**PUBLIC HEARING MEMORANDUM**

SUBJECT: **Petition #394-22**, to rezone ~~parts of the following 2 parcels: 136-144 Hancock Street (Section 43 Block 31 Lot 01) and 169 Grove Street (Section 43 Block 31 Lot 16)~~ from SINGLE RESIDENCE 3 TO MULTI RESIDENCE 2.

**Petition #395-22**, for SPECIAL PERMIT/SITE PLAN APPROVAL to allow multi-family dwellings, to allow single-family attached dwellings, to allow a reduced rear setback, to allow reduced lot area per unit, to alter and extend a nonconforming side setback, to waive parking stalls, to waive perimeter screening requirements and to waive lighting requirements at **136-144 Hancock Street and 169 Grove Street** Ward 4, Newton, on land known as Section 43 Block 31 Lots 01 and 16 containing approximately 58,492 sq. ft. of land in a district zoned SINGLE RESIDENCE 3 (rezone to MULTI RESIDENCE 2 proposed). Ref: Sec. 7.3.3, 7.4, 3.4.1, 3.2.4, 4.1.3, 7.8.2.C.2, 5.1.4, 5.1.13, 5.1.9.A.1.ii, 5.1.10.A of the City of Newton Rev Zoning Ord, 2017.

**136-144 Hancock St.**

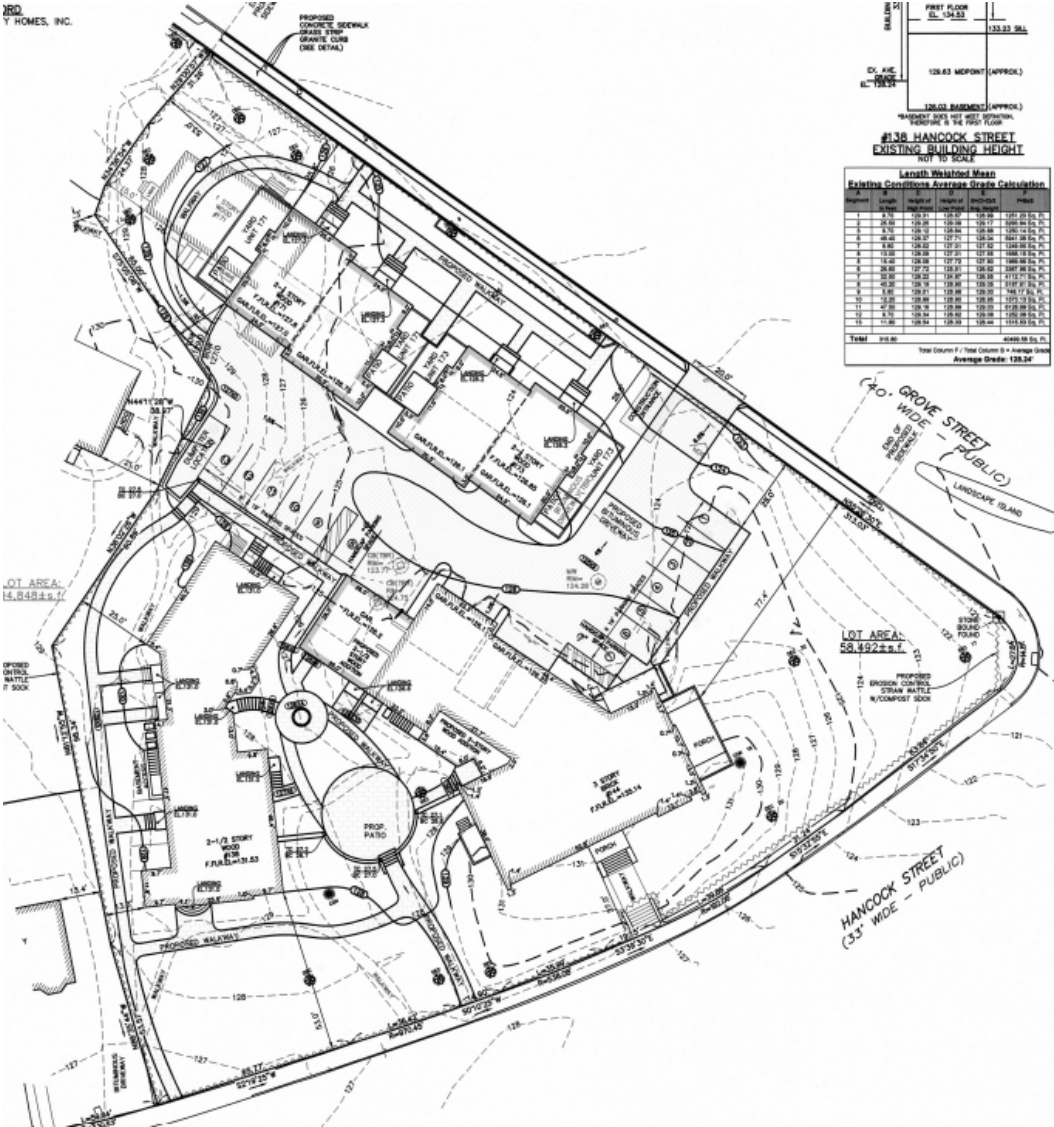
The subject site consists of a 58,492 square foot lot at the intersection of Grove and Hancock streets. The property is improved with multiple buildings constructed between 1850 and 1957 and used as a nonprofit ecumenical retreat and inn.

The lot is generally level, sloping upward approx. six feet from south to north. Vehicular access is provided via curb cut on Grove Street serving the existing parking between that public way and the center's structures. The property features lawn areas and mature trees.
